UNITED STATES PATENT AND TRADEMARK OFFICE

Office Action Summary

10/606,875

HAYMOND, BRADLEY J.

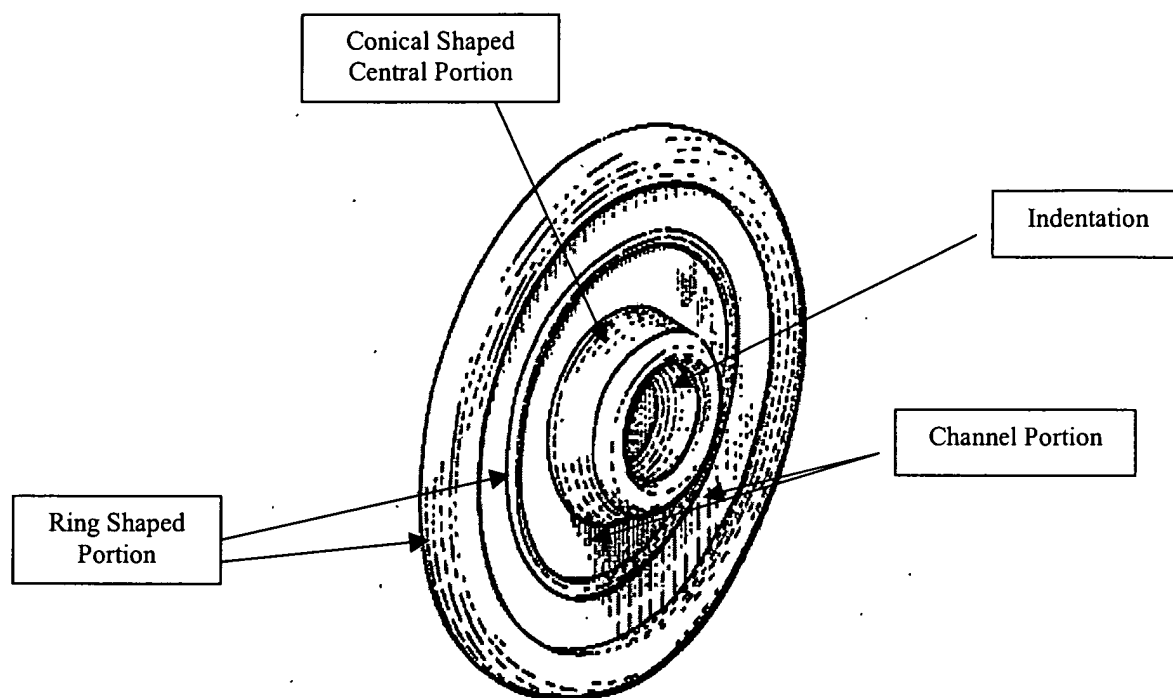
2. Claims 1-4, 6, 8, 15-18, and 20 are rejected under 35 U.S.C. 103(a) as being unpatentable over Owens et al., US Patent Des.324,170, in view of Morse et al., US Patent 3,050,770. As shown in the below figure, Owens discloses essentially all of the claim limitations. As best understood, the claimed dimensions of thickness of the ring portion are shown. Owens does not explicitly disclose resilient material, or a continuous solid center portion, as claimed. Such limitations are highly known and very old to one skilled in the art. Morse shows these modifications for the purpose of providing a damping door stop member. It would have been obvious at the time the device was made for one skilled in the art to have included such a modification in the device of Owens, as generally taught by Morse, for the purpose of providing a damping door stop function, as known in the art.
